Chaney Instrument Co.

Subject: Requesting Class II permissive change for FCC ID: RNEVN1TXCA1

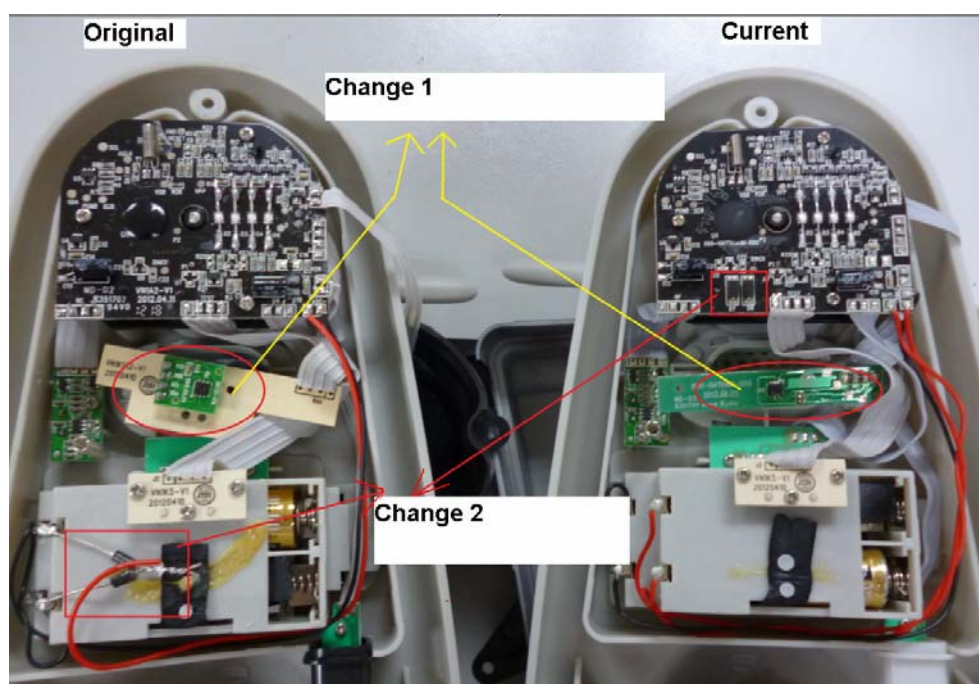
The Major change filed under this application is:

- 1) A PCB board changes from welding to an adapter board to patching directly to another larger PCB board.**
- 2) Two diodes change from soldered to a plug to patched to a PCB.**
